Site Report 12

GEOTECHNICAL INSPECTION PROPOSED RESIDENTIAL DEVELOPMENT 195 – 197 SYDNEY ROAD, FAIRLIGHT, NSW

Plate 1 (looking south)

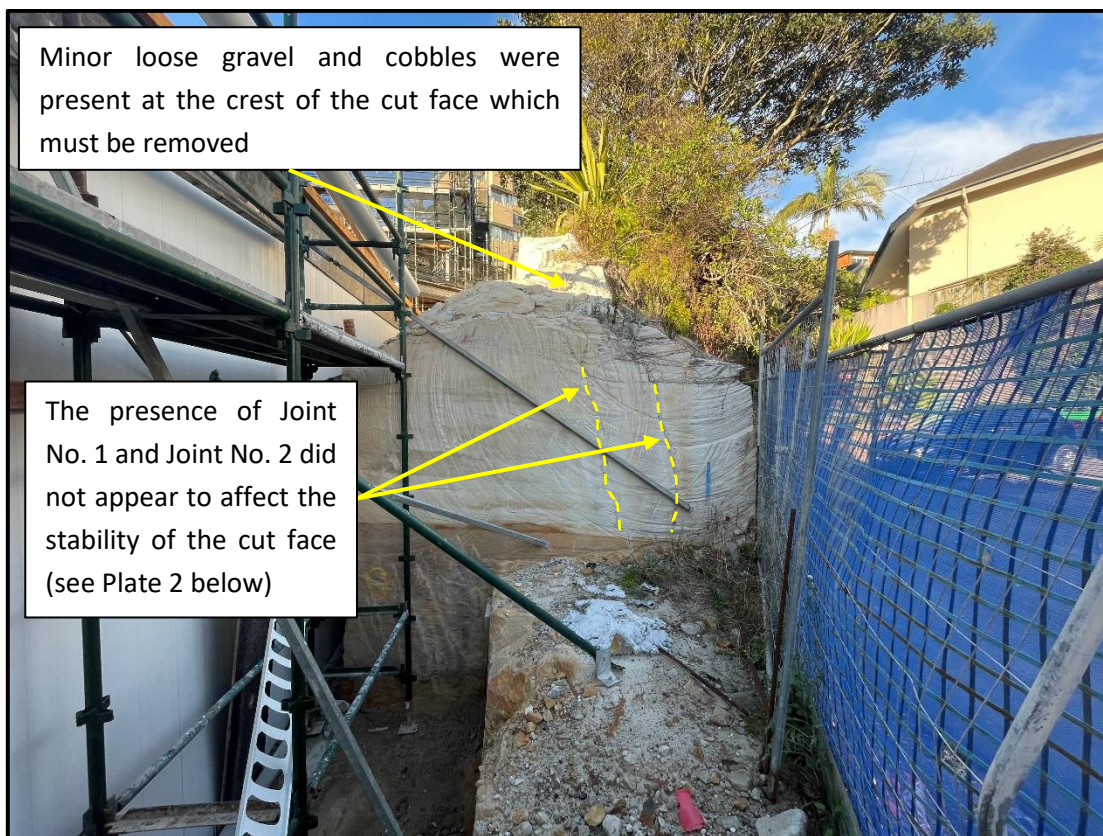
Prior to our arrival on site, excavation within the subject site had been completed and the building fit out was ongoing. The sandstone cut face located between the subject site and neighbouring property to the west had been excavated in a roughly east-west direction and ranged in height between approximately 1.8m and 2.2m above neighbouring surface levels; see Plate 1 below. Based on a visual and tactile assessment with a geopick, the cut face exposed slightly weathered sandstone bedrock of medium strength. Two sub-vertical joints trending (i.e. striking) at approximately 162° (Joint No. 1) and 132° (Joint No. 2) were further exposed in the cut face, however these joints did not appear to daylight within the cut face above the neighbouring carpark; see Plate 2 below. Lastly, some minor loose sandstone gravel and cobbles were scattered across the crest of the cut face.

From our most recent site inspection on 20 July 2023, we consider that the excavation along the western site boundary between approximately Grid Line L and R has been carried out in accordance with the advice presented in our previous site reports.
